SERVICE LETTER

NUMBER: DK3022

SUBJECT: X+90 ADJUSTMENT ON 200 TPI UNITS

FIGURE 6-15 (b)

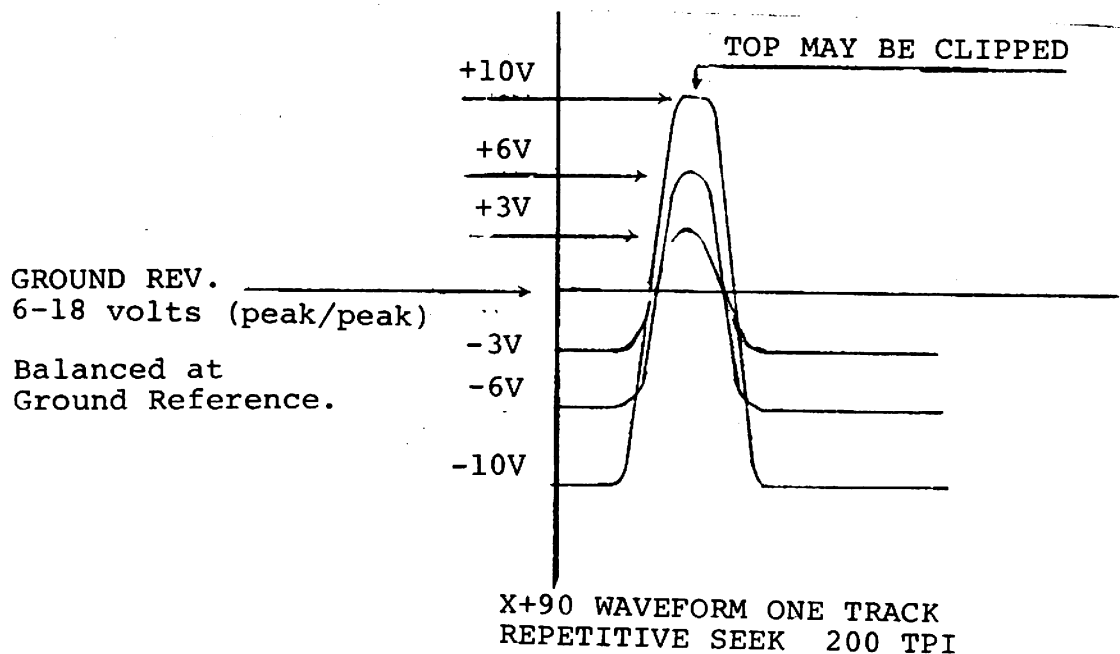
PURPOSE: Presently there are no differences outlined in the D3000 Manual (102780) on the X+90 adjustment for 100 TPI and 200 TPI Disk Drives. D3000 Manual (102780) outlines 100 TPI, X+90 adjustment only. This adjustment is not adequate for use on 200 TPI Disk Drives. The following procedure must be utilized when making the X+90 adjustment on 200 TPI Disk Drives.

6.9.7.4 ADJUSTMENT PROCEDURE - 200 TPI ONLY

- (1) Select Channel 2. Adjust potentiometer R79 (X+90). Balance until the X+90 waveform at TP2 is balanced at ground.
- (2) Select Channel 1. Observe settling response of the X+0 waveform at TP20. If the response overshoots greater than + 2.0v about ground, readjustment of the reticule is required (6.9.6.4).
- (3) Select Channel 2. Establish that the X+90 waveform at TP2 has transistions balanced about ground reference as shown in Figure 6-15(b), adjust R79, if necessary.
- (4) Connect Channel 2 test probe to TP13. Change Channel 2 sensitivity to 2v per division. Set Channel Select switch to ADD. Observe that SPQCG signal added to X+0 waveform occurs at greater than +4v on the positive peak and more negative than -4v on the negative peak when balanced about ground as shown in Figure 6-14(b). (Sweep rate of 0.5 msec per division may be desirable.)
